PL 201900127  
PL 2019-127  
Skywater Tech Foundry  
2401 and 2411 East 86th Street

**Sheet Title**  
**LANDSCAPE PLAN**

**Sheet No. Revision**  
**L1.01**

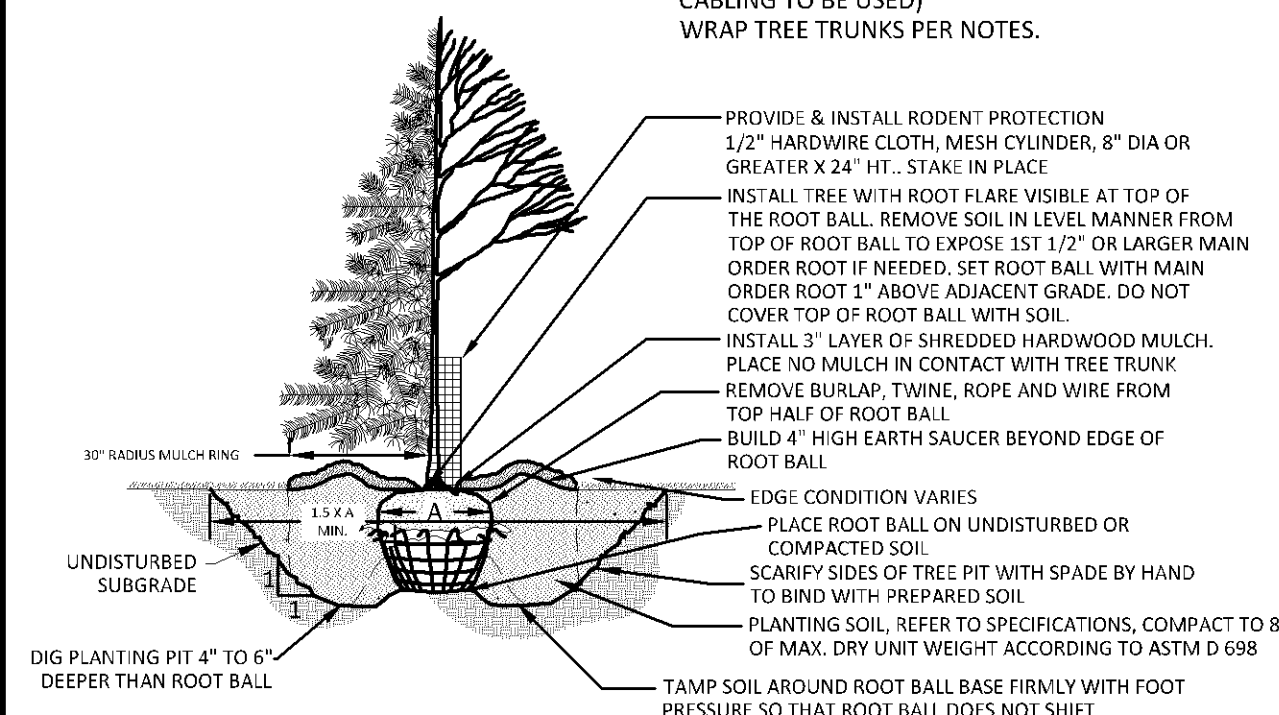
1 calculate disturbance area as 125,000 SF as seen on C5.02. Additional 10 trees would be needed. Please verify disturbance area.
